Proposal for amendment to document AEBS/LDWS-TF02-03-Rev.2
(Monitoring of braking demand signal)

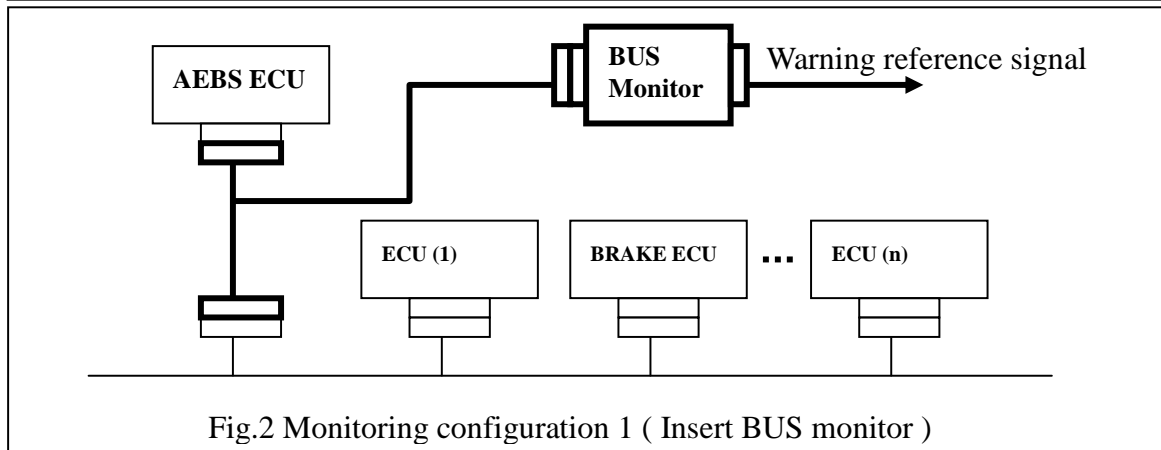
Monitoring configuration 1 (Fig.2) is the ordinary case for evaluation of the braking demand signal by using a bus monitor tool. The whole vehicle system is operated by the real production components except the bus monitor tool. Monitoring configuration 2 (Fig.3) shows there is a special reason such as there being no signal which shows the braking demand on the bus. Therefore Special ECU is needed for type approval testing in this configuration.

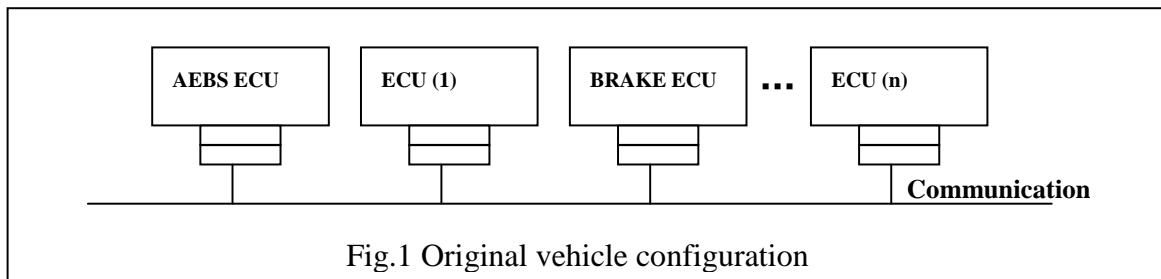
Particularly, since configuration 2 is not a production component, the manufacturer needs to give detail explanation of signal flow in advance that the Special ECU and production component are identical. From the perspective of type approval tests, case 1 is more preferable in terms of simplicity.
